APPLICATION NO: 02/2022/0736/ PF

PROPOSAL: Erection of 1 no. detached dwelling, provision of parking area for no. 149 and associated works

LOCATION: Land at (Part garden of) 149 Mwrog Street Ruthin LL15 1LE

Proposed site layout plan

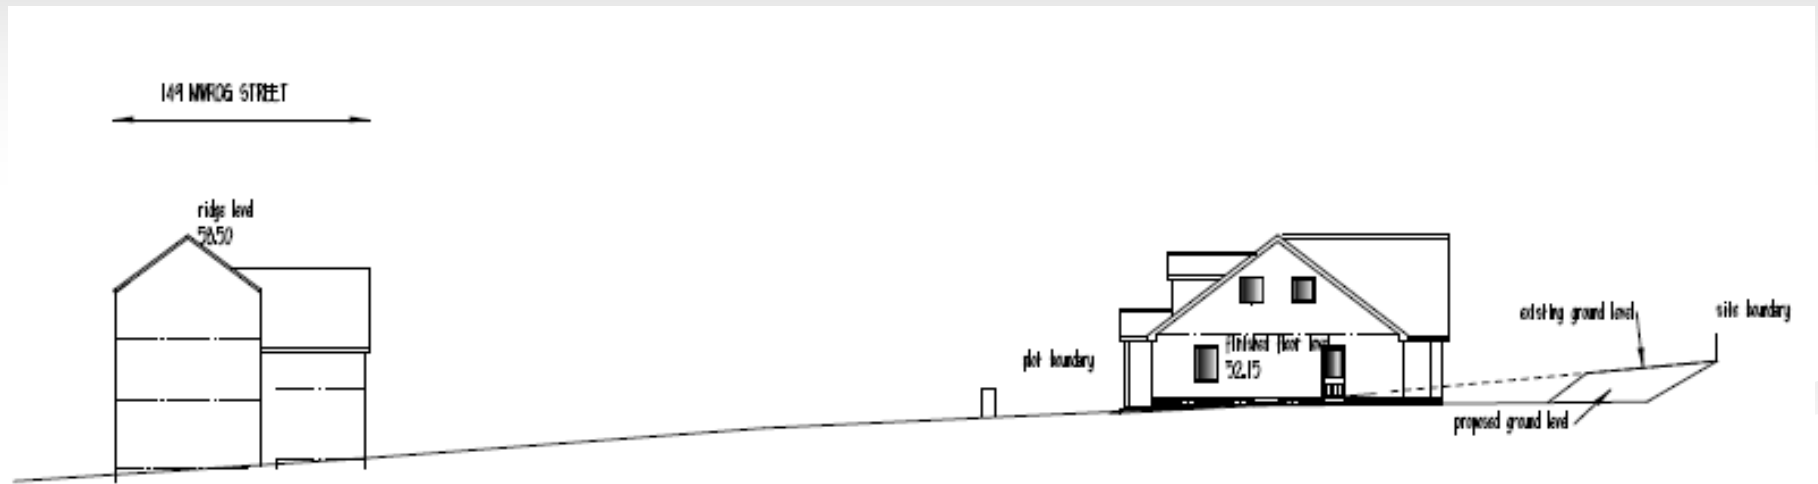
The site is crossed by a public sewer. No building will be permitted within 3m either side of the centre line of the sewer. Recommend the site layout take into account the location of the assets crossing the site. Confirm capacity exists within the public sewerage network in order to receive the domestic foul only flows from the proposed site.

- o Confirm that the new 1800mm timber fence to the boundary of no. 151 is located on top of the wall for clarity, Omit concrete fence posts and include timber posts, the fence is to be painted in an appropriate heritage colour i.e. Heritage Green
- o The stone boundary wall should be noted on the plans as being re-built to match existing height
- o The roof light is to be shown and noted as a conservation roof flight
- o Specify the type/product of stone setts for the drive
- o Confirm the material of the posts to the front porch
- o A higher quality paving material than concrete slabs needs to be specified
- o Show on the landscaping plan the extent of where the rear garden is being reduced in level/graded and how it effects the existing trees to be retained.
- o Roofing material to be noted as Natural Slate

Proposed access amendments to wall

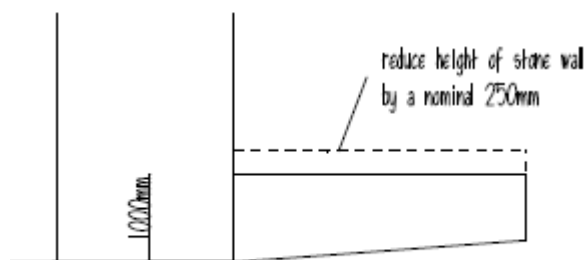
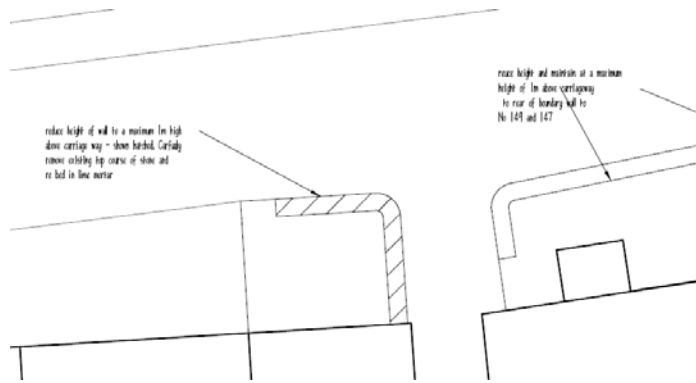
- 1.1.8 A section of the retaining boundary wall to the west is proposed to be removed and a parking area cut out of the higher level garden of 151. Stone is proposed to be reclaimed to rebuild the wall with lime mortar around the parking area and a timber panel fence painted in heritage green is proposed to be erected above the wall to enclose the garden area of 151.
- 1.1.9 Alterations are proposed to the existing access include lowering the wall to the west of the entrance at 151 Mwrog Street to 1m above the carriageway and finished in lime mortar to improve the visibility splays. The access to the east is to remain as an existing hedge but will be maintained to a maximum height of 1m above the carriageway.

The proposal also proposes to alter the existing access onto Mwrog Street which currently serves the rear garden and parking area of 149 Mwrog Street. The proposal includes alterations to the front boundary wall of 151 Mwrog Street to the west (not a listed building). The alterations involve lowering this wall by to a maximum of 1m high above the carriageway and carefully removing the existing top course of stone and rebedding the wall in lime mortar to match the existing. The Conservation Officer has raised no objection to this alteration but has requested details of the coping is submitted for approval.

14. Notwithstanding the hereby approved plans, prior to the works commencing on the front wall of No. 151 Mwrog Street, full details of the coping detail shall be submitted for approval in writing by the Local Planning Authority. The development shall be carried out in accordance with the approved details.
